Richland County Transit Board: Questions and Responses to Computer-Aided Dispatch/Automatic Vehicle Location (CAD/AVL) System Upgrade

Posted: Friday, August 4, 2023

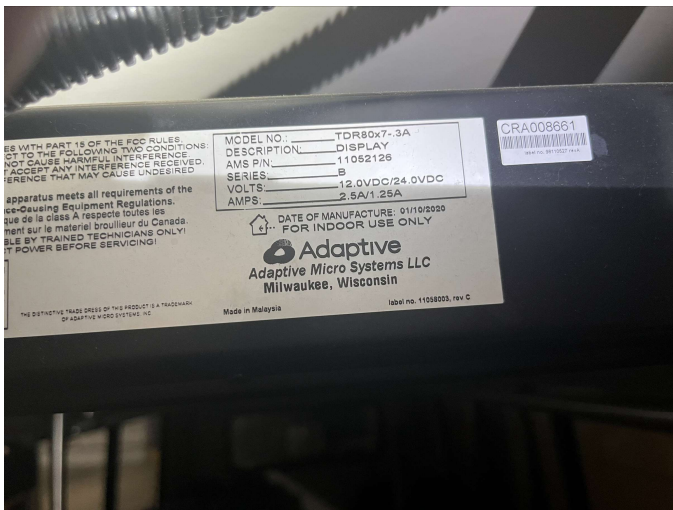
8. What is the current age of the Luminator interior signs? Make/Model etc.?

Answer: The exterior signage, headsign and passenger side signage, is the property of the RCT. The make model of exterior signage is Illuminator Twin Vision. The interior signage was provided by and is property of the current CAD/AVL vendor. Addendum #1 to the RFP offering a correction to ownership of the onboard signage and clarification on onboard equipment needs will be issued in conjunction with this document. The make and model of the current onboard signage is illustrated as follows:
